Re: Docket No. 516 – The United Illuminating Company Application for a Certificate of Environmental Compatibility and Public Need for the Fairfield to Congress Railroad Transmission Line 115-kV Rebuild Project

Enclosed for filing with the Connecticut Siting Council (“Council”) are The United Illuminating Company’s responses to the Fairfield Station Lofts, LLC’s September 14, 2023 interrogatories.

Attachment FSL-1-1

FSL - EXHIBIT 1A

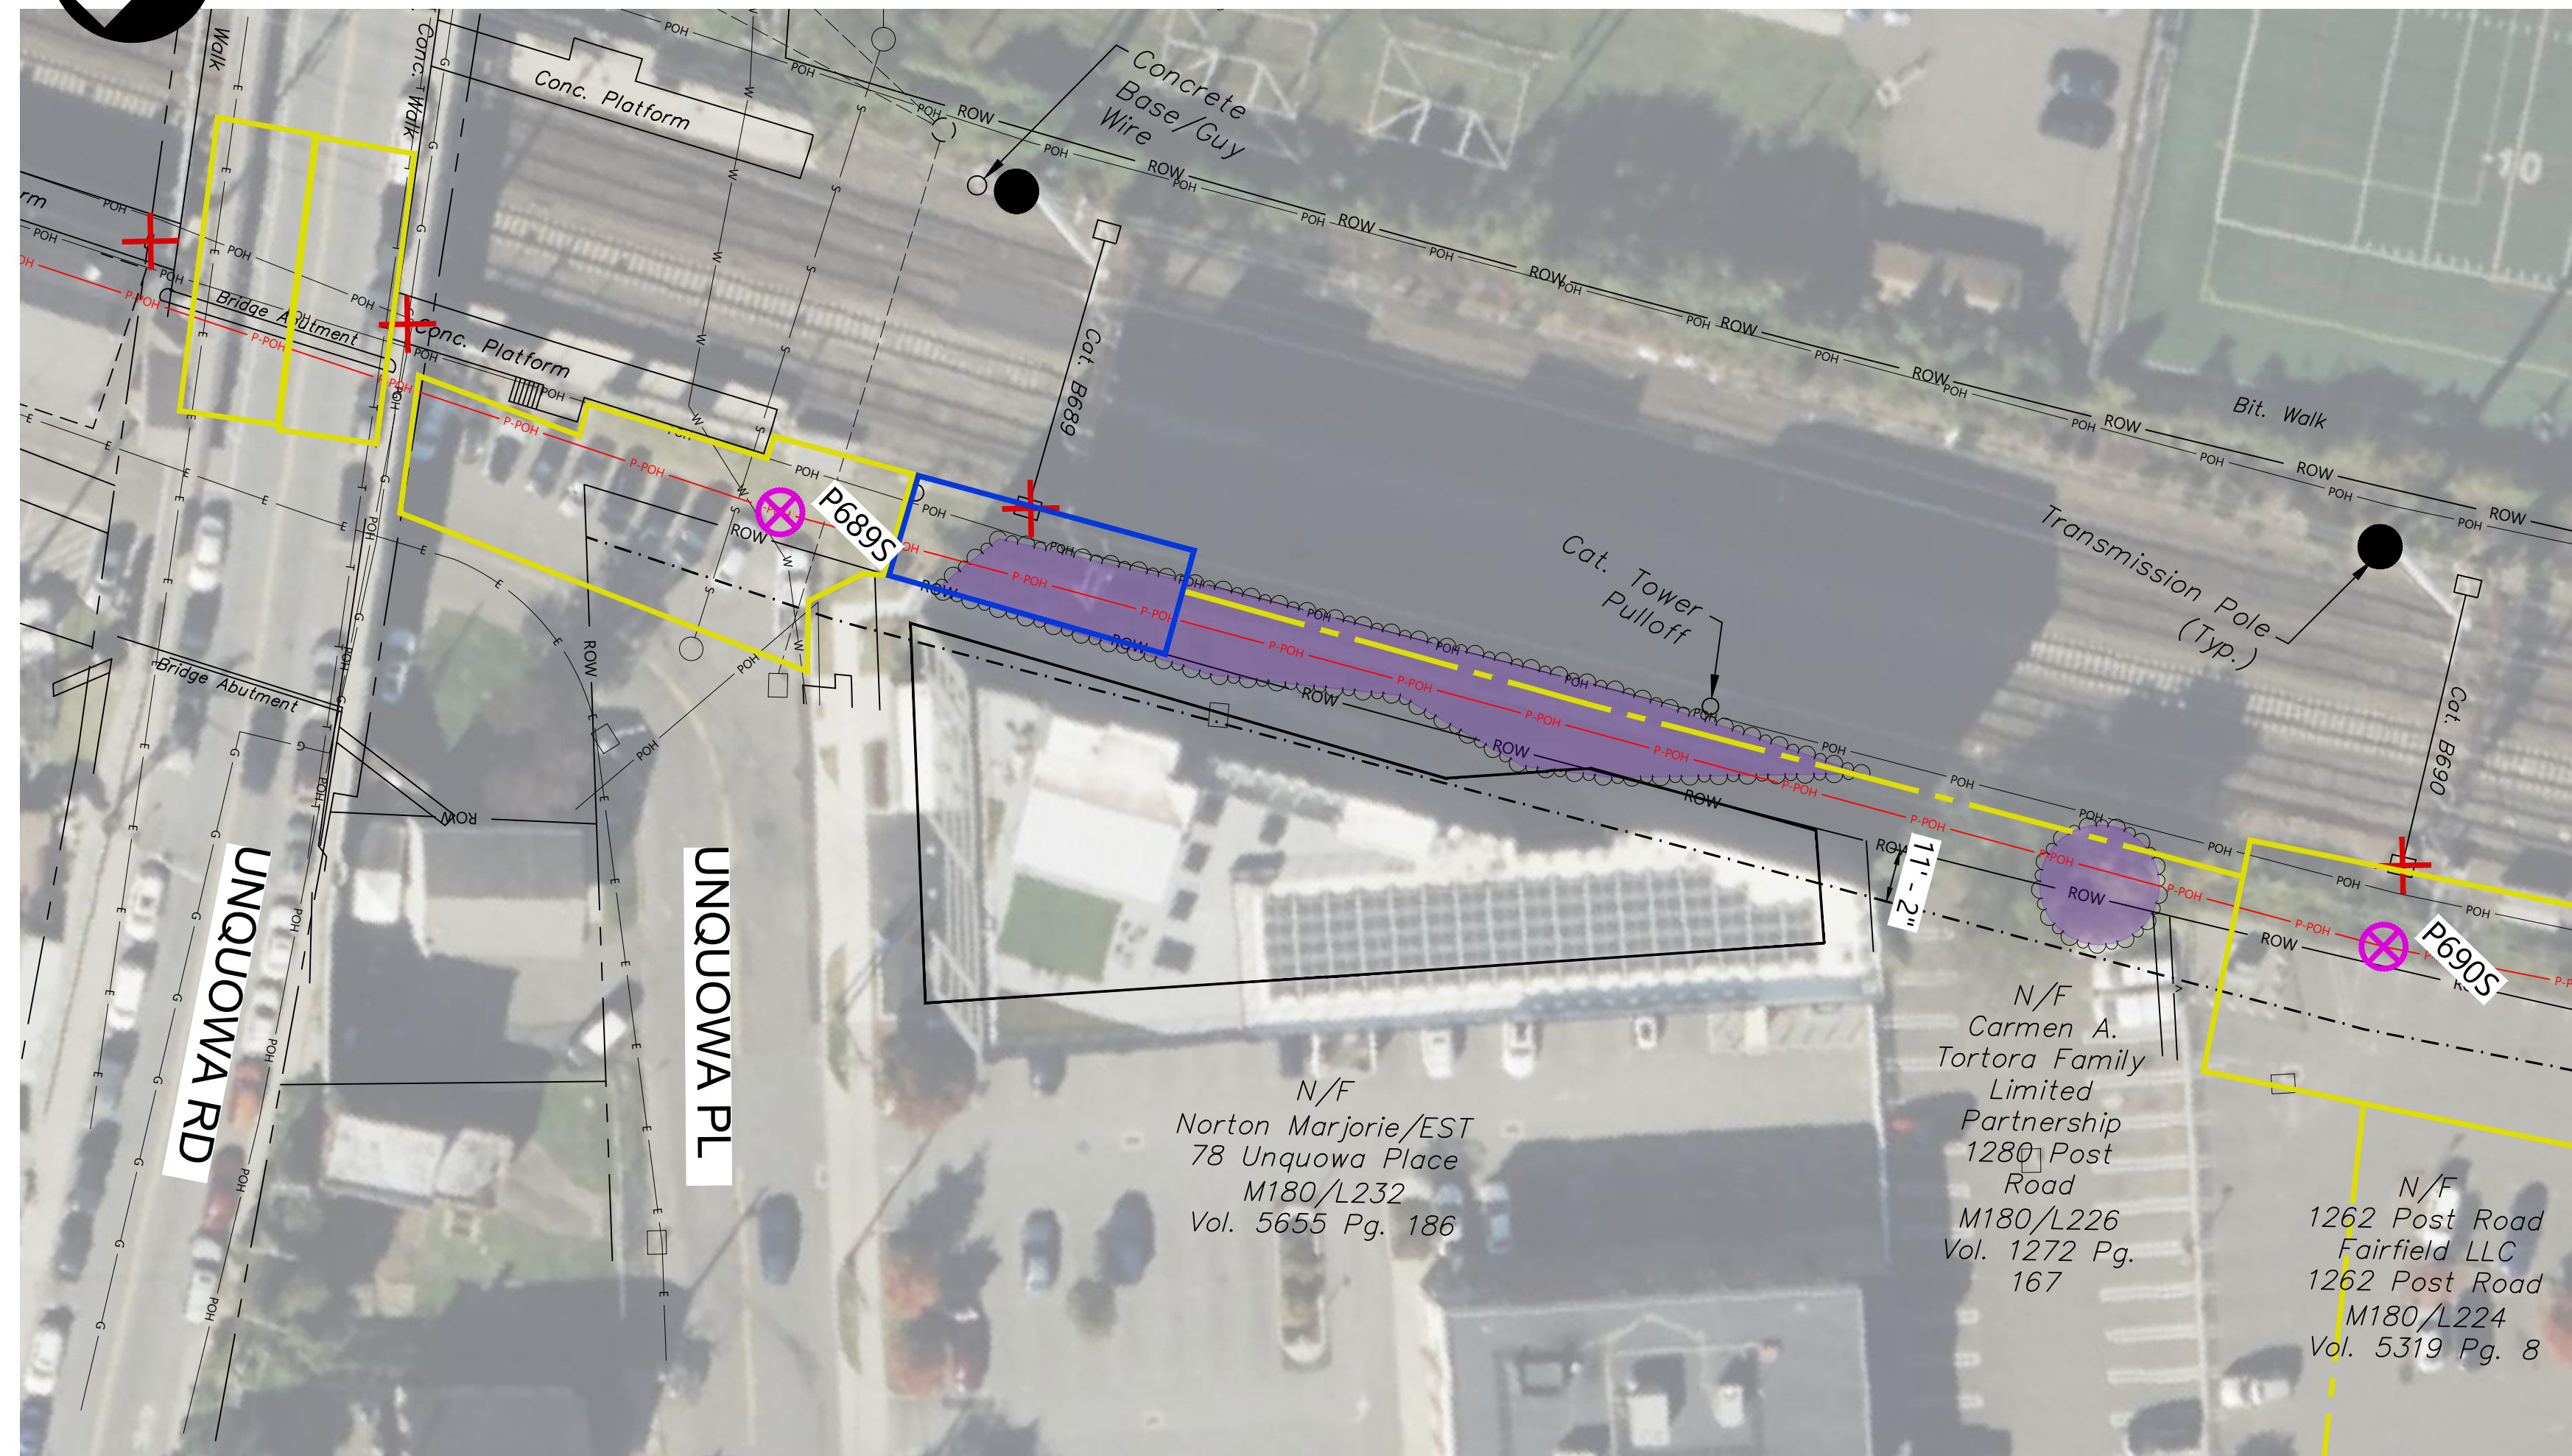
Q-FSL-3: Provide the precise location for proposed Tower P689S, including the precise location depicted on a survey with sufficient detail to understand the proximity of the proposed Tower P689S to property SAS-1754 and the actual distance from Tower P689S to the nearest portion of the Fairfield Apartment Building.

Q-FSL-16: In connection with the proposed work pad related to proposed Tower P689S:

- a. Describe in detail the nature of this work pad, including the activities that will take place in the work pad area, expected duration of this work pad area, and any restrictions that will impact adjacent areas (e.g., the Fairfield Apartment Building) as a result of the activities in and around the work pad area.

- b. Does this work pad extend onto property SAS-1754? If so, where and for what purpose?
- c. Will this work pad be secured with fencing or other perimeter control measures?

- d. Can this work pad be reduced in size or moved away from the Fairfield Apartment Building to avoid impacting the SAS-1754 parcel and building?
- e. When designing this work pad, including its location and size, did UI evaluate whether the location and size of the work pad would impede residents' access to the Fairfield Apartment Building or the ability of emergency services to access the westerly side of the Fairfield Apartment Building?

A-FSL-3: See Attachment FSL-1-1 for more information. In the application, the proposed location of Structure P689S is approximately 7'-4" away from the property line of SAS-1754 and 20'-8" away from the apartment building. The revised location of Structure P689S is approximately 23'-6" away from the property line of SAS-1754 and 36'-3" away from the apartment building.

- A-FSL-16:
- a. See Note 3 in Attachment FSL-1-1, Exhibits 1A and 1B.
 - b. The work pad does not extend onto property SAS-1754.
 - c. No. The work pad that is located in front of the apartment building will utilize the existing pavement. The work pad that is shown over the grassy area to the northwest of the building will consist of construction matting to allow for equipment access.
 - d. The work pad does not impact the SAS-1754 parcel. Further, for the revised design, the work pad will not impact the sidewalk located in public space on the west side of apartment building.
 - e. Yes. The work pad will not impede residents' access or emergency services to the Fairfield Apartment Building. The work pad in front of the building will utilize the existing paved area and work pads in the grassy area will utilize construction matting which is designed for use by construction equipment.

- PROPOSED POLE LOCATION:** THE ORIGINAL DESIGN IN THE APPLICATION PLACES THE POLE AND FOUNDATION FULLY ON THE CTDOT RAILROAD CORRIDOR, 7' - 4" FROM THE CORNER OF THE FSL PROPERTY AND 20' - 8" FROM THE CORNER OF THE APARTMENT BUILDING.

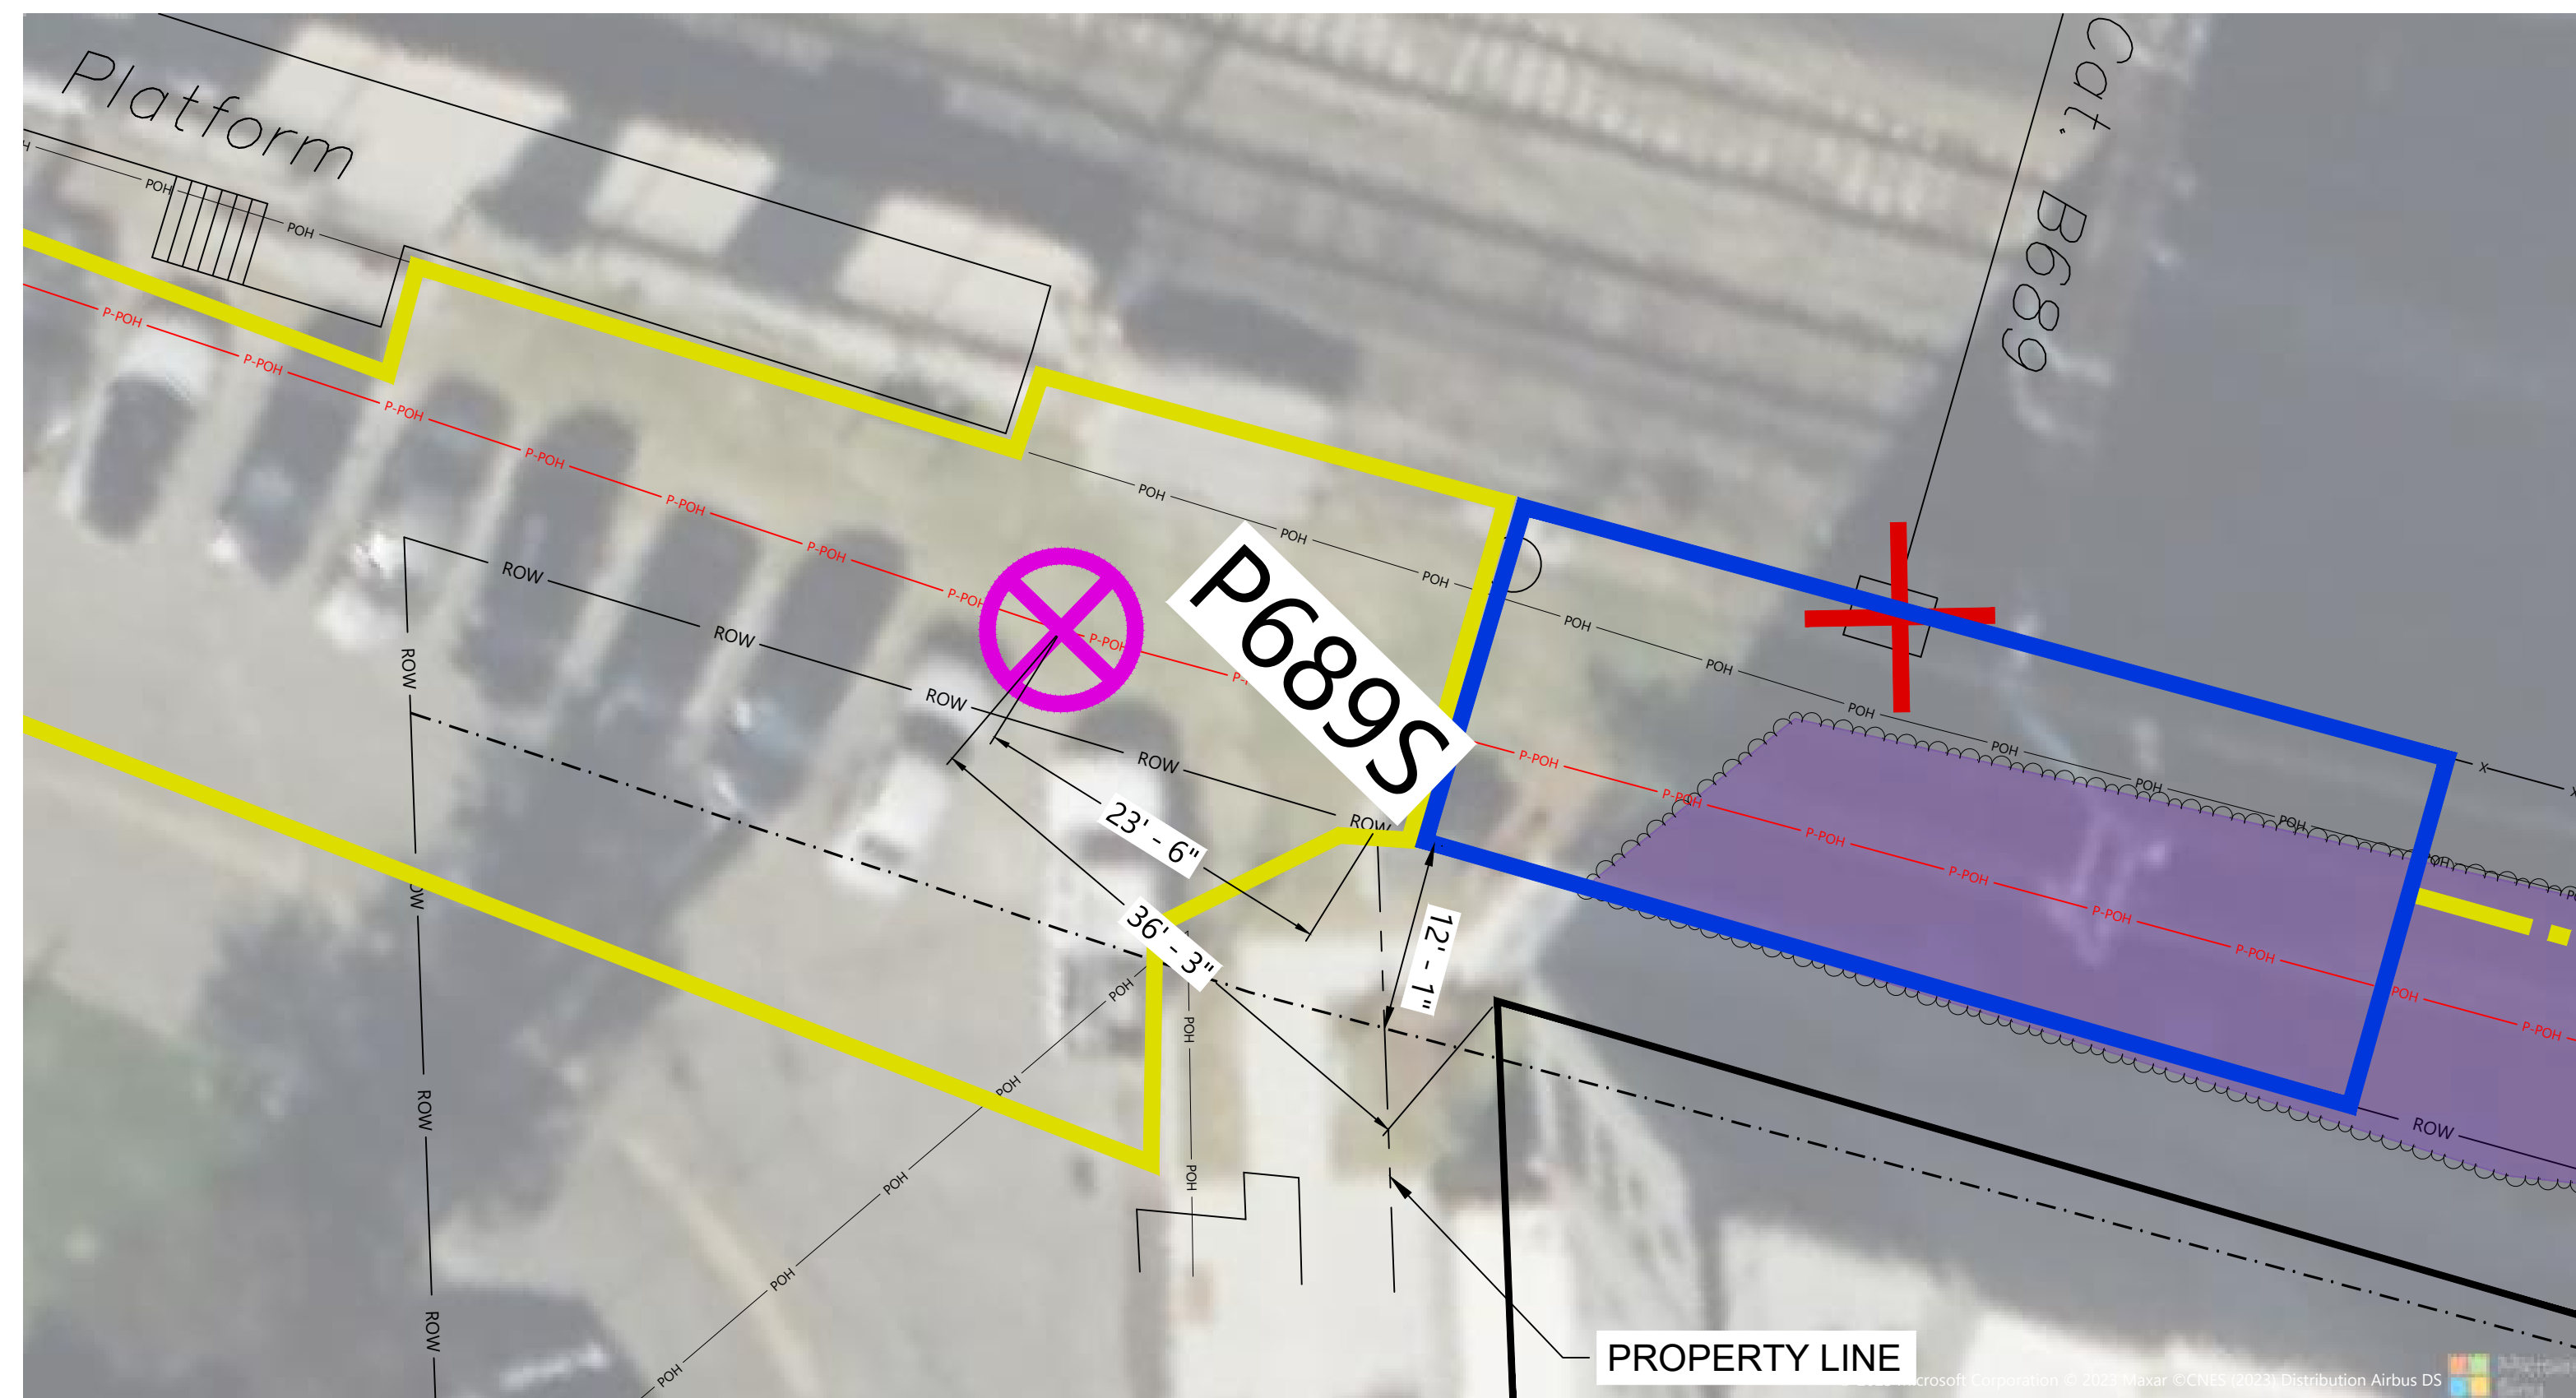
Q-FSL-2: In preparation of the Application in this Docket, did UI modify the location of Tower P689S or the associated electric transmission lines once it became aware of that SAS-1754 contained a five-story multi-family apartment building approved pursuant to Conn. Gen. Stat. § 8-30g, Connecticut's affordable housing statute (the "Fairfield Apartment Building")? If so, describe any modifications in detail.

Q-FSL-5: When deciding on the location of proposed Tower P689S, did UI consider if the location would impede access to the westerly side of the Fairfield Apartment Building for, among other things, emergency services? If so, how did that impact the proposed location of Tower P689S?

Q-FSL-6: When deciding on the location for proposed Tower P689S and the associated electric transmission line connecting to the proposed Tower P690S, did UI take into consideration the relocation of electric distribution pole P3745 in 2022 and the reasons for that relocation discussed in the December 8, 2021, Decision of the Public Utilities Regulatory Authority in Docket No. 21-06-18?

A-FSL-2: No. However, following the site walk discussed in FSL-1, UI evaluated and modified the location of the transmission pole P689S from what is presently shown in the submitted application. Please refer to Attachment FSL-1-1, Exhibit 1B for updated pole location.

A-FSL-5: Yes, UI considered the location of the new pad mount transformer location as well as access for emergency services to the westerly side of the apartment building. The revised location of the pole will accommodate space for emergency service access to the building.

A-FSL-6: When deciding the location of the new transmission pole, as depicted in Attachment FSL-1-1 Exhibit 1B, UI considered access to the northwest corner of the building. The location of the transmission pole and wires will not impact access to the western side of the building as described by the fire chief in PURA Docket No. 21-06-18. The transmission wires and pole will be located to the north of the new apartment complex.

- PROPOSED POLE LOCATION:** THIS OPTION SHIFTS THE POLE 18' WEST COMPARED TO THE ORIGINAL LOCATION IN THE APPLICATION, 23' - 6" FROM THE CORNER OF THE FSL PROPERTY AND 36' - 3" FROM THE CORNER OF THE APARTMENT BUILDING.
